PUBLIC HEARING MEMORANDUM

PETITION #08-23

41 Washington Street

Application #08-23- 41 TusNua LLC, requesting a Comprehensive Permit, pursuant to M.G.L. Chapter 40B, to construct a 16-unit residential unit development on a 25,902 square foot lot located at **41 Washington Street** within a Single-Residence 3 (SR3) zoning district. The proposal includes four affordable ownership units.

1 PROPOSED SIDE ELEVATION-WEST
A104 1/8" = 1'-0"

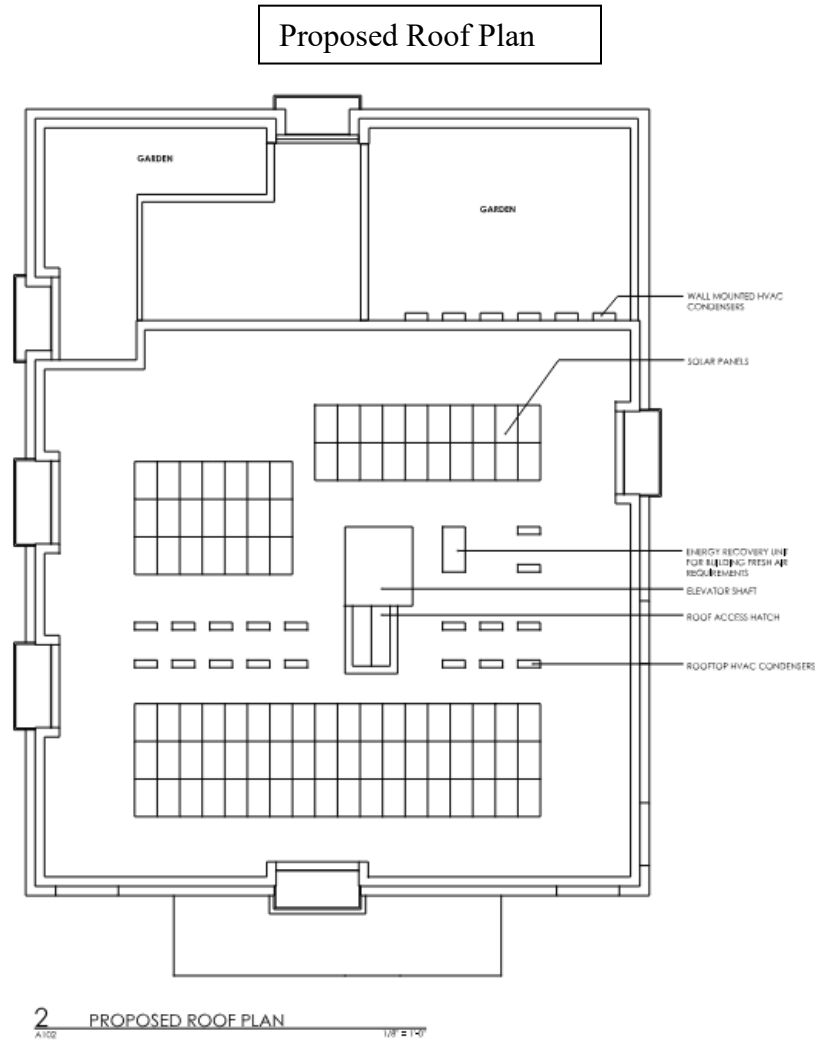
To create a level rear yard, the applicant proposes two terraced retaining walls, six feet apart, that reach a cumulative height (bottom of the lower wall to the top of the higher wall) of approximately nine feet. They are outside of the 15-foot rear setback, thus did not require zoning relief (due to the time of filing). The applicant is proposing screening along all lot lines and is not proposing anything on the portion of the lot that juts out at

In the memorandum prepared for the April 3rd hearing, Planning raised concerns with the size of the project in terms of the floor area ratio (FAR) which is proposed at 1.16, over three times the maximum allowed within the single residence 3 zoning district (.36). A revised FAR worksheet for the project was provided to Planning which places the square footage at 30,033 square feet in floor area. All previously proposed dimensional controls remain the same, meaning there have not been any changes to the footprint or the height of the building since March 8, 2024. The FAR remains at 1.16, where .36 is the maximum allowed as of right for the SR-3 zoning district. The Planning Department previously recommended that the Applicant consider other ways to articulate massing such as projections and stepping back the upper stories to mitigate the impact of the large building. The balconies, recessed living rooms, and contrasting colors shown on the architectural plans all help towards achieving this directive.

The applicant also submitted details of the proposed roof plan which shows solar panels, rooftop mechanicals such as HVAC condensers as well as roof top gardens/green roof and a deck area. The rear of the roof will be enclosed by a 3.5-foot-high parapet wall.

Planning previously raised concerns with the front entry of the building which is approximately seven feet above the ground elevation. The applicant is providing both stairs and elevator at the front of the dwelling. Planning requested more information on the elevator based on feedback from the City's ADA Coordinator, Jini Fairley. Ms. Fairley noted new construction should have a ramp or walkway for all visitors and this configuration may require a variance from the Architectural Access Board. The location of the bicycle rack near the elevator also may present a conflict if the rack were to become overloaded with bicycles and impede in front of the path to the front porch elevator. The Applicant has not provided any updated information on this topic.

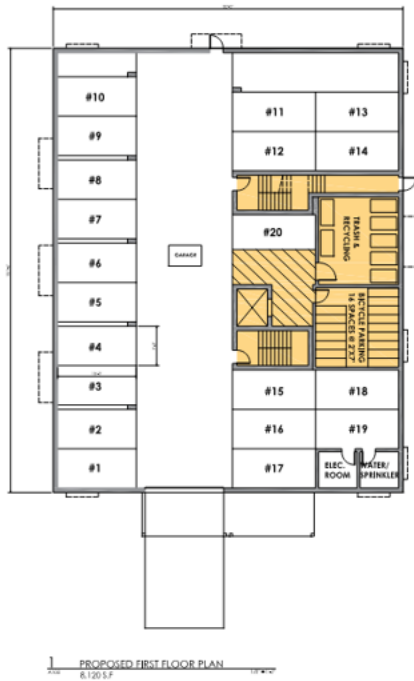
Much of the discussion focused on roof form, with the Applicant stating the flat roof allows them to maintain the 16-unit program, and a pitched roof would not allow for the same number of units on the top floor. The UDC believes that a pitched roof would appear “more residential” and perhaps there is a middle ground. Overall, the UDC expressed a desire for this proposed building to appear more residential and pointed to examples at 77 Court Street, a 36-unit Comprehensive Permit project and new construction on California Street where wood panels were used in contrast with white panels. The UDC has not reviewed the changes submitted on June 26 and Planning believes these changes help the project appear “more residential”.

One of the members of the UDC thought the design was more appropriate than the prior iteration, as it is a more efficient design, and the vehicles are no longer visible nor taking up open space.

March 2024 First Floor Plan

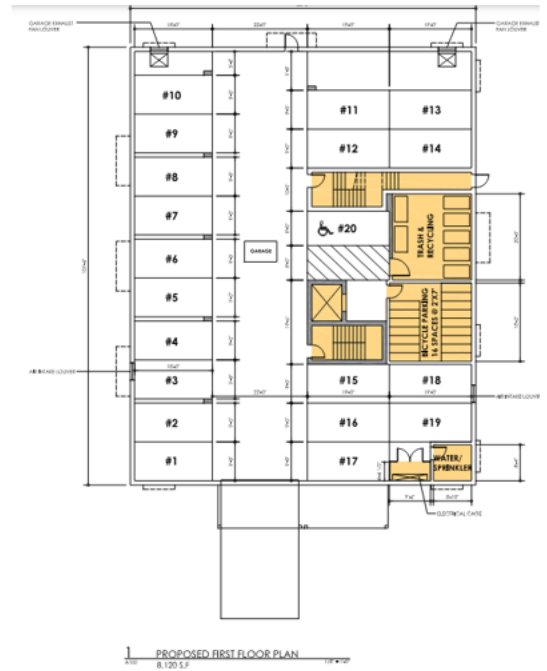
A revised first floor plan for the garage was submitted which shows minor modifications to the floor plan. BSC, the City’s peer reviewer for traffic and circulation reviewed the materials submitted June 26 and issued as subsequent response (**Attachment B**). They noted that the requested narrative for how the parking spaces will be assigned and how the parking design meets the requirements of Section 5.1.8.E.1, and confirmation that the electrical room and water/sprinkler meets building code requirements was not provided. The Applicant provided a narrative regarding trash and recycling operations with the trash room being large enough to accommodate seven wheeled 2-yard dumpsters which are each approximately 3 feet wide x 3 feet high x 6 feet long. These dumpsters are designed to be moved by a single person. Residents will bring their trash and recycling down the elevator or stairs and deposit the bags in the appropriately marked dumpsters. A private trash and recycling company will be retained by the condominium association. This company will decide on an appropriate number of times per week (one or more) to service the building based on the volume of trash generated.

Their employees will wheel the dumpsters from the trash and recycling room to a truck parked at the curb. The truck uses lifts to empty the dumpsters into the truck. Employees will wheel the dumpsters back into the trash and recycling room for use by the residents.
